Our Ref: SSD-2025/9
Our Contact: Angela Lazaridis (02) 9562 1719

Bayside Council submission on State Significant Development Application for 68-80 Banks Avenue Pagewood (SSD-83256472)

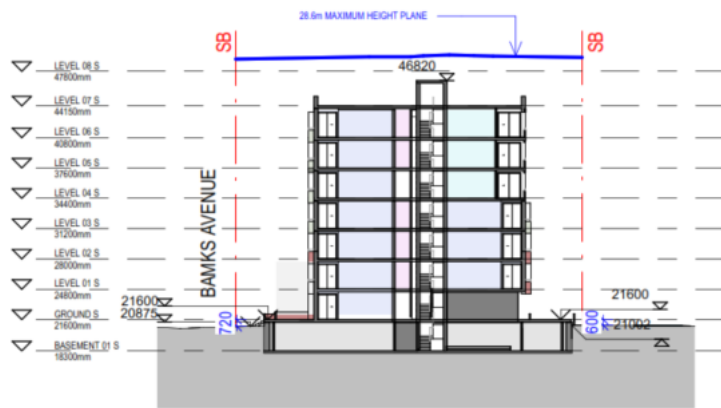
- q) The post development flood modelling has used the building footprint of the residential tower in the flood modelling. However, the basement footprint is larger than the tower footprint and the basement is raised above ground level. This means that the basement footprint will create impact on the floodplain not just the tower footprint. This means that the flood modelling of the tower footprint only is not correct and the post-development modelling be revised to incorporate the basement footprint and all changes to the existing ground levels surrounding the building. See below sections which show the extent and raised levels of the basement footprint.
